# **The Town of Hilton Head Island Regular Design Review Board Meeting**

**Tuesday, May 25th, 2010**

## DESIGN TEAM/ DRB COMMENT SHEET

PROJECT Hilton Head Pizza Company

**F1** *Left Elevation*

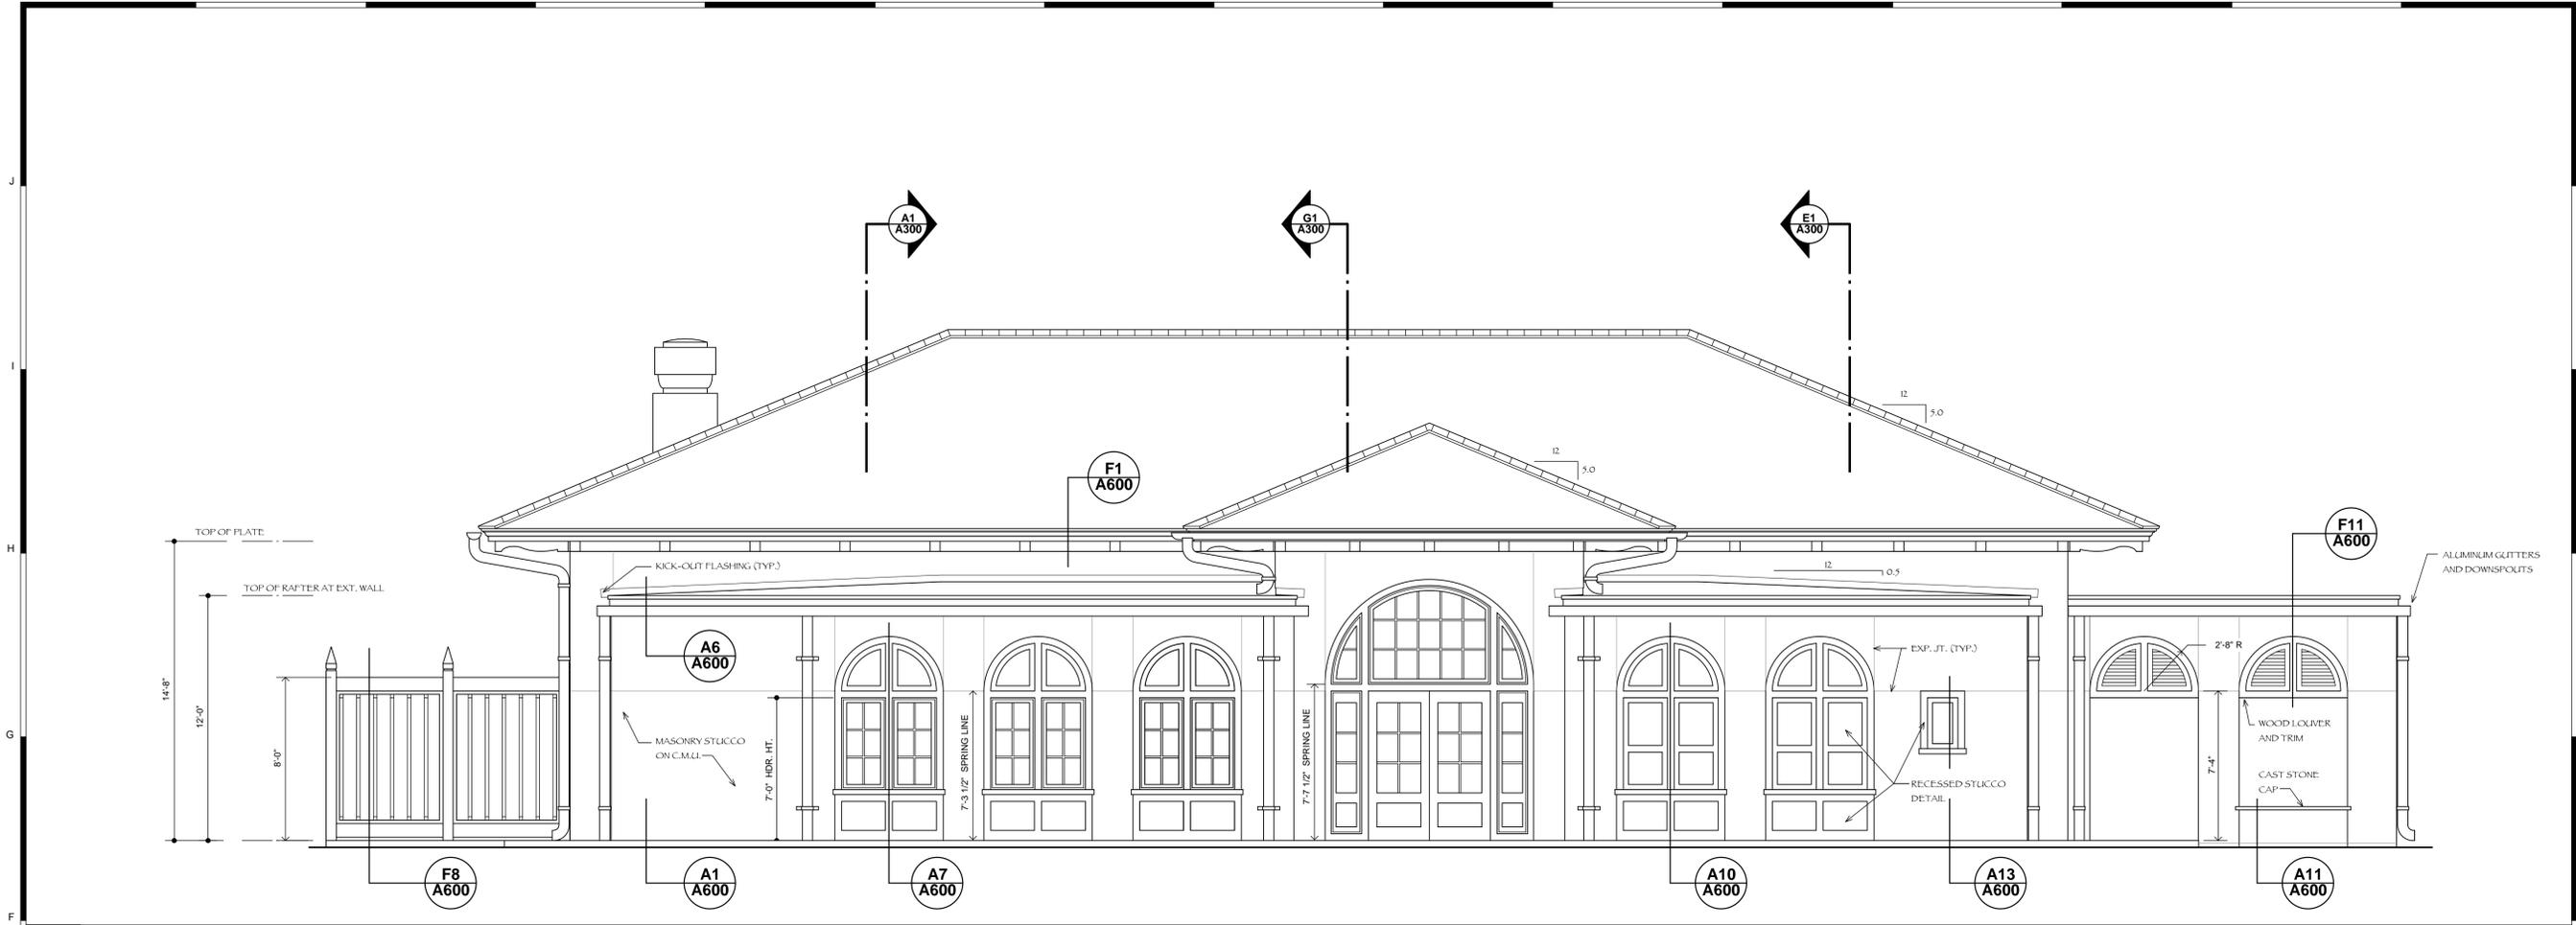
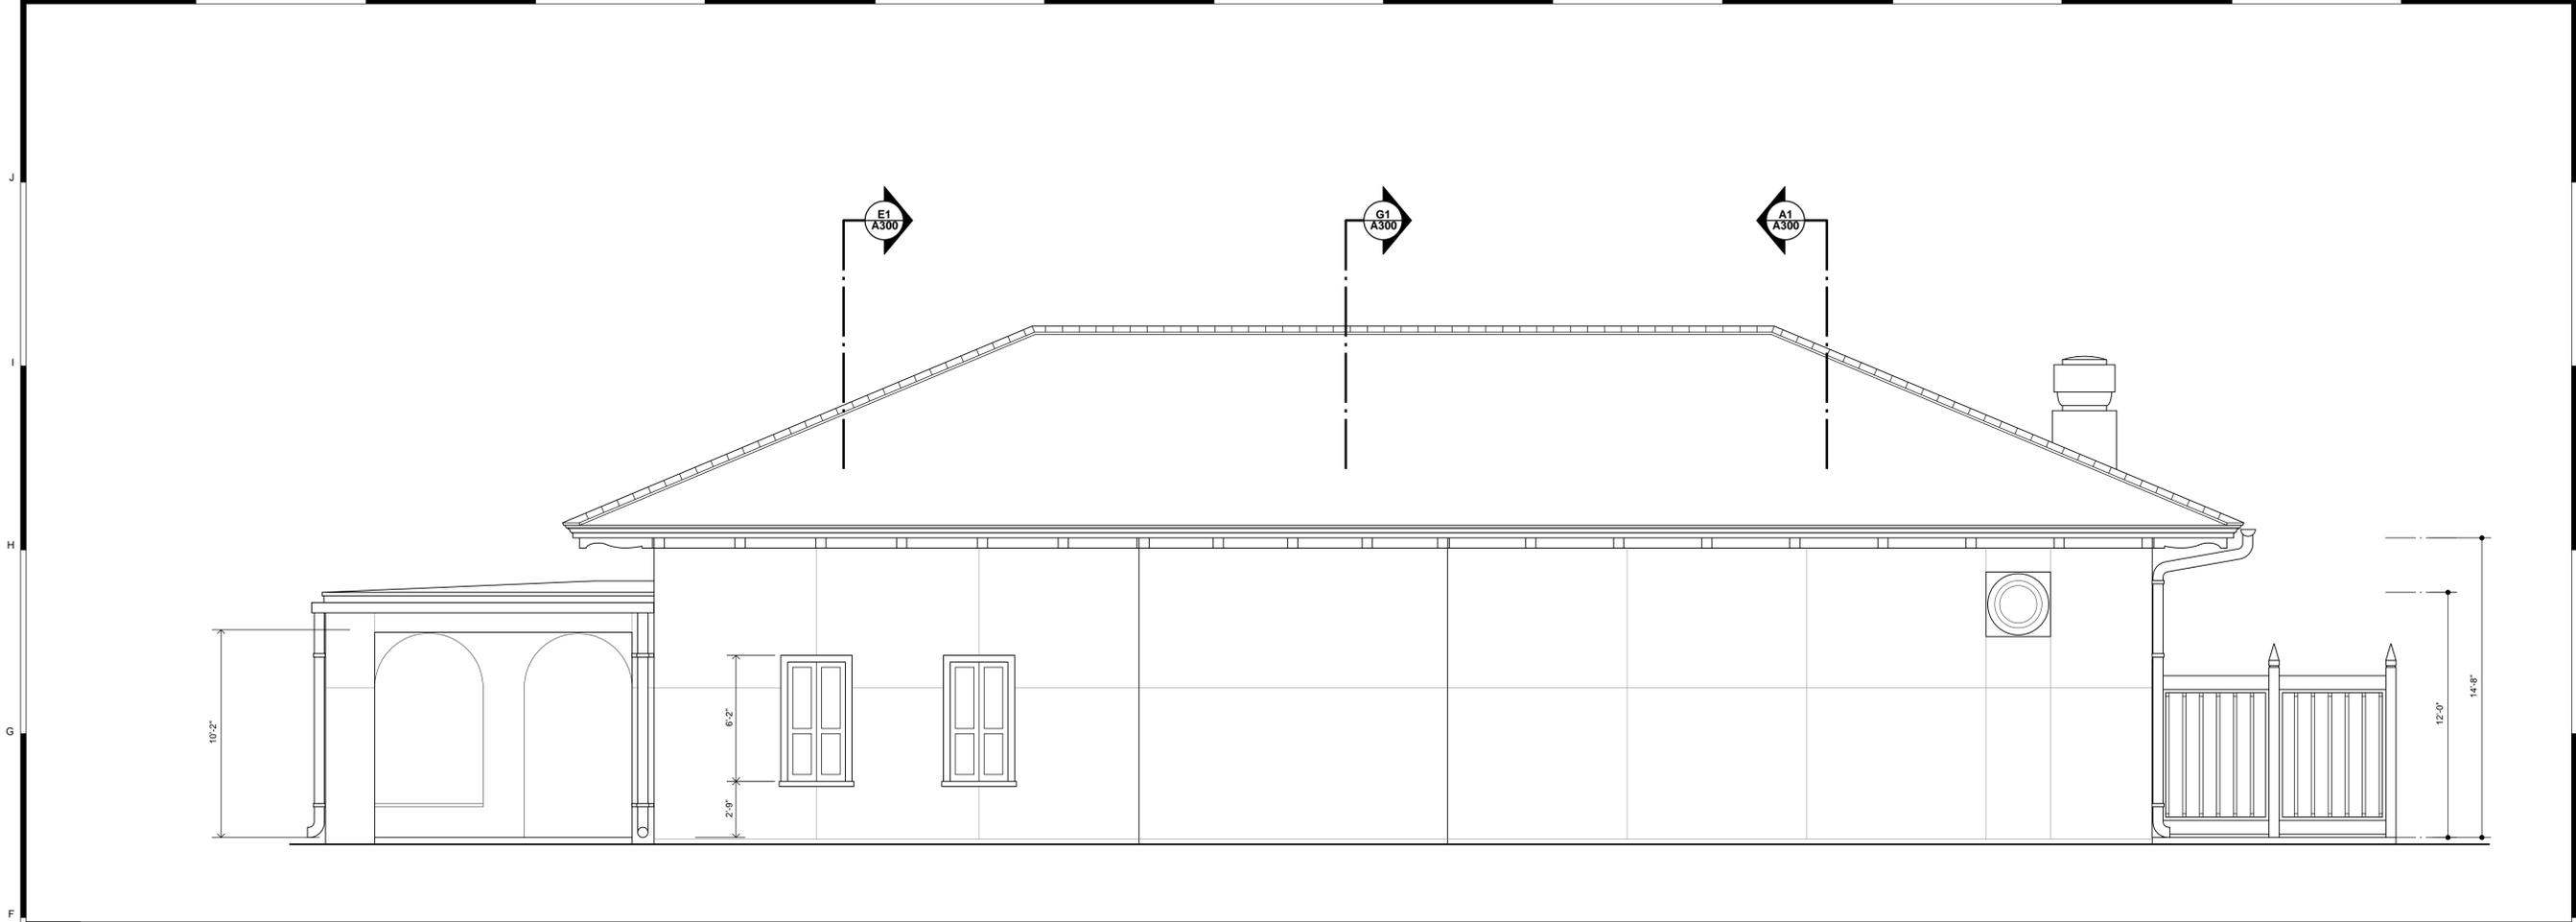
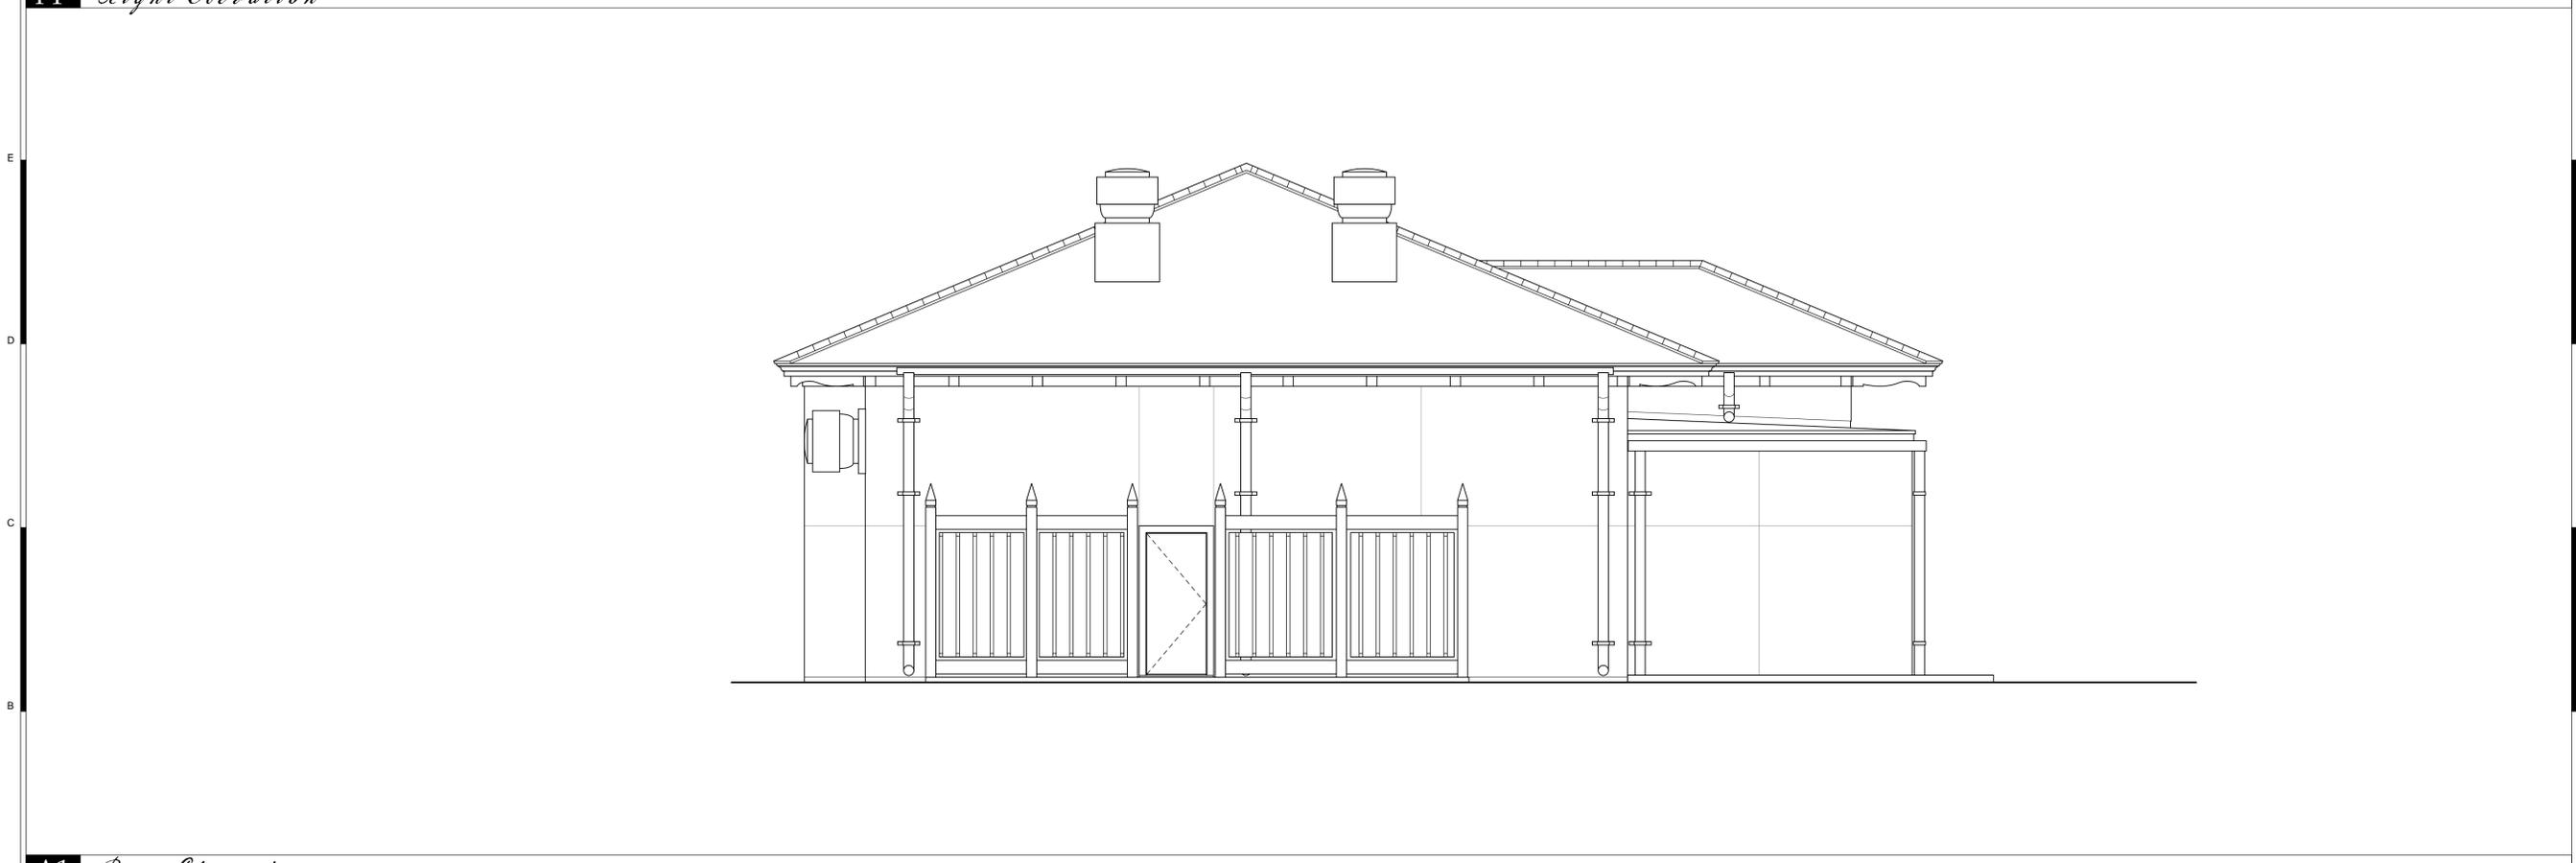
Minimum roof pitch of 6/12	Y/N	5/12 is appropriate to the building. Dining porch and roof on left elevation have a very low pitch, and propose a waterproof membrane for the roofing material. This very well could be an invisible detail behind the flashing and gutters, but the exploration of an alternative was discussed by the Board
Overhangs are sufficient for the façade height.	Y	
Forms an details are sufficient to reduce the mass of the structure	Y	
Human scale is achieved by	Y
